4395A-13A

## S E R V I C E N O T E

### Agilent 4395A Network/Spectrum/Impedance Analyzer

Part number changes for LCD

### COLOR LCD ASSY (E4970-65001) part:

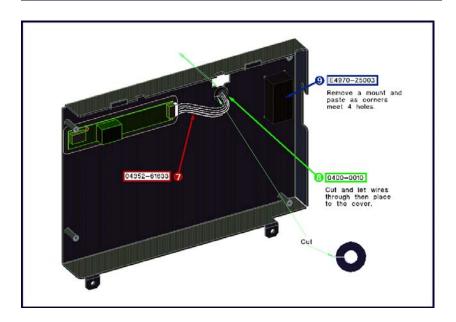
The LCD (P/N 2090-0574) used in the 4395A was obsoleted and replaced with a new LCD. When the LCD is defective, use new replacement LCD P/N 2090-0361 or LCD ASSY P/N E4970-65001.

The new LCD has different assembly size from old one and is used with a new inverter board for backlight. The LCD and GSP board are required for replacing the LCD depending on instrument serial number.

Ref Desig	Agilent Part Number	Qty	Description
1	04352-04014	1	Cover
2	04352-25002	1	Insulator
3	0950-4111	1	A54 Inverter Board
4	0515-0977	2	SCR-MACH M2X0.4
5	2090-0361	1	A52 LCD
6	04396-25071	1	Gasket
7	04352-61633	1	Cable Assy
8	0400-0010	1	Gromet
9	E4970-25003	1	Sponge
10	E4970-66540	1	LCD MINI-BD
11	0515-1550	4	SCR M3-L8 P-H
12	E4970-61651	1	FLAT CBL FFC
